Howell Mill Road Safety Audit Report, 7-28-2015 DRAFT

RSA Overview

Included in this document is the final report and recommendations for the July 2015 pedestrian-focused Road Safety Audit (RSA) of the Howell Mill Road corridor. The boundaries for this RSA are Northside Dr. and Marietta St. on the south side and Collier Rd. on the north side (see figure 1).

Figure 11

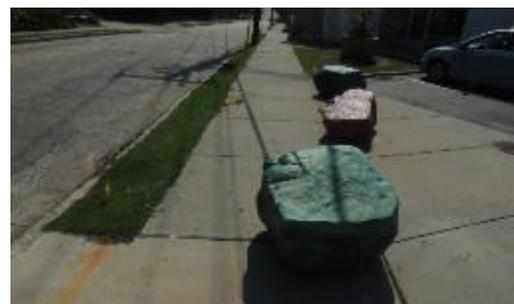
The RSA team recommends moving the painted boulders out of the sidewalk on the southeast side of the intersection of Howell Mill and 8th St. These decorative pieces, just outside of Bocado Restaurant’s parking lot, are a sidewalk obstruction (figure 11).
